**Re: Strata Energy, Inc. Ross In Situ Recovery Project
Source Materials License SUA-1601, Docket No. 040-09091
Response to License Condition 10.13 Critical Verification Issue for
Mine Unit 1 Wellfield Data Package**

Critical Verification Issue #2 –

Figure 2. Trilinear Diagram Comparing MU1-PM19 Major Ion Chemistry with Average of Other PM Wells and SM Wells

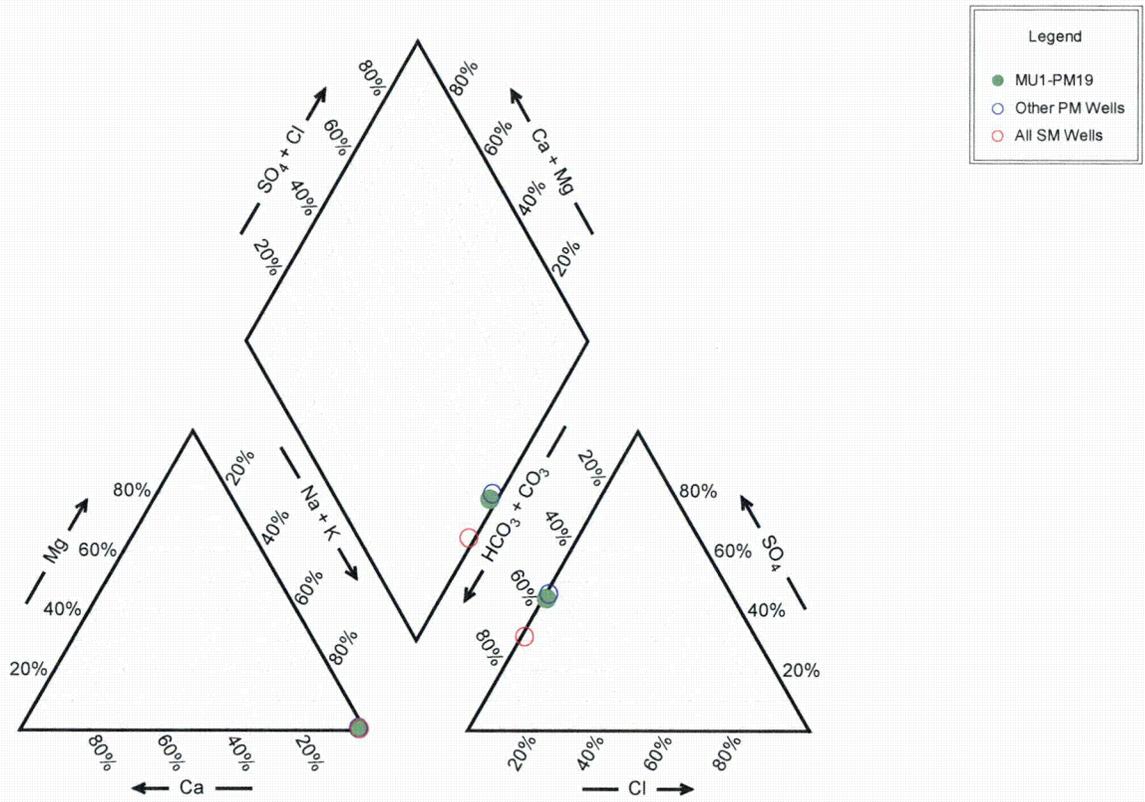
“License Condition 10.13 states: ‘The wellfield package will adequately define heterogeneities that may affect the chemical signature and ground-water flow paths within the ore zone as described in Sections 2.7.3.2.3, 3.1.1 and 5.7.8.1 of the approved license application.’ ... Strata has not addressed the issue of whether or not the perimeter wells along the southern boundary of the wellfield are in contact with the overlying aquifer. If correct, then Strata did not adequately define whether or not the wells’ ability to detect an excursion is diminished, whether or not the wells should be converted to partially penetrating wells, or whether or not an adequate thickness of the overlying confining unit exists in this area. Therefore, staff cannot verify that Strata met this license condition.”

- Figure 2 compares the major ion water chemistry in MU1-PM19 with that in the remaining PM wells and all of the SM wells using average concentrations. This figure shows that the major ion chemistry in MU1-PM19 is virtually indistinguishable from that in the remaining PM wells. This demonstrates that the water quality in MU1-PM19 is consistent with and representative of the water quality in the PM monitoring interval within MU1.

- Regarding the SM interval, Figure 2 shows that the major ion chemistry at MU1-PM19 is clearly distinct from that in the SM interval within MU1. The relative proportion of sulfate is significantly lower and the relative proportion of bicarbonate/carbonate is significantly higher in the SM interval compared to MU1-PM19 and the other PM wells. These differences in water quality provide evidence of hydraulic separation between the SM and OZ aquifers within MU1 generally and specifically at MU1-PM19.
